IMPORTANT SAFETY RECALL

NHTSA Safety Recall #26V-177
Winnebago #203

Lense Visual Reference

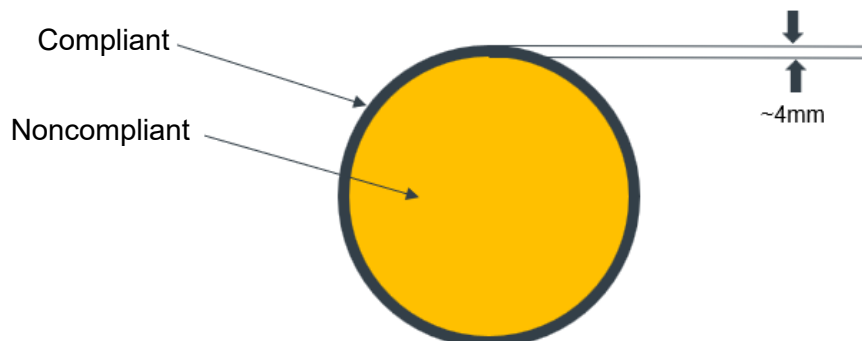
On certain motorhomes, the front turn signal lights may be too small. As a result, the turn signals could be difficult to see. A turn signal that is difficult to see could cause a person not to recognize when a driver intends to turn or change lanes. This could increase the risk of a crash.

An update to federal safety standards in 2012 increased the required area of vehicle light lenses by **4 mm** to improve visibility. The front turn signal light on some vehicles may not meet the updated surface area requirements.

On affected vehicles, Winnebago dealers will replace the front turn signal lights. This repair will take approximately 1 hour. **This repair will be done at no charge to you.**
